# Access Compliance Report

## Public Rights-of-Way

Intersection ID: 2658	Main Street: CRESTWICK_CT	Cross Street: FAIRVISTA_DR	Location: NE
ADA ID: 95BF66E49C8B	Ramp Type: PerpDiag	Initial Pass/Fail: Fail	Overall Compliance: No
Severity Score: 13.75			
Codes/Mitigation Info/Possible Solution		Field Measurements/Component Compliance

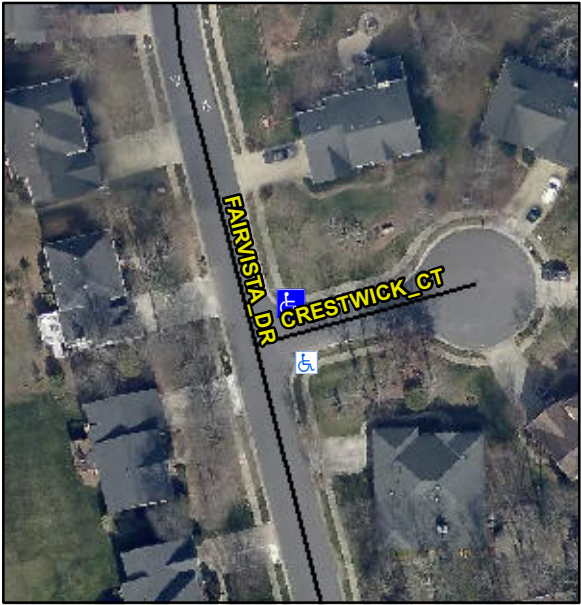
Possible Solutions:	Compliance	Description	Data	Compliance	Description	Data
	Remove & Replace Curb Ramp With Two New Directional Ramps or Equivalent.	N/A	Ramp Length (in)	48.0	No	Ramp Slope (%)	9.0
		Yes	Ramp Width (in)	48.0	No	Ramp XSlope (%)	4.2
		N/A	Flare Type LT	N/A	N/A	Flare Type RT	N/A
		N/A	Flare Slope LT (%)	N/A	N/A	Flare Slope RT (%)	N/A
		N/A	Flare Traversable LT?	N/A	N/A	Flare Traversable RT?	N/A
		N/A	Landing Length (in)	N/A	N/A	DWS Provided?	N/A
		N/A	Landing Width (in)	N/A	N/A	DWS Contrast?	N/A
		N/A	Landing Slope (%)	N/A	N/A	DWS Length (in)	N/A
		N/A	Landing X Slope (%)	N/A	N/A	DWS Full Width?	N/A
		N/A	Landing Curb? (Y/N)	N/A	N/A	DWS Offset (in)	N/A
		N/A	Shared Landing?	N/A			
		N/A	Gutter Ponding?	N/A	N/A	Gutter Slope (%)	N/A
		N/A	Gutter Lip Ht (in)	N/A	N/A	Gutter X Slope (%)	N/A
		N/A	Painted X Walk1?	No	N/A	Painted X Walk2?	No
			X Walk 1 Direction	To W		X Walk 2 Direction	To S
		N/A	X Walk 1 Width (in)	N/A	N/A	X Walk 2 Width (in)	N/A

X Walk 1 Slope (%)	2.0		X Walk 2 Slope (%)	2.8
			X Walk 1 X Slope (%)	3.9		X Walk 2 X Slope (%)	4.2
		N/A	Ramp inside XWalk1?	N/A	N/A	Ramp inside XWalk2?	N/A
<p>Surveyor Notes:</p> <p>N/A</p> <p>PROW/ADA:</p> <p>Not Found, R304.2.2, R304.5.3</p>			Road Slope (%)	5.3	N/A	Clear Space?	N/A
			Road X Slope (%)	1.7	N/A	Clear Space to XWalk (in)	N/A
<p>Total Cost:</p> <p>\$ 3200.00</p>		N/A	Any Obstructions?	N/A	N/A	Storm Grate/Utility Hazard?	N/A
			Obstruction Type			Storm Grate/Utility Type	
					N/A		N/A
					Yes	Surface Condition? (G/P)	Good
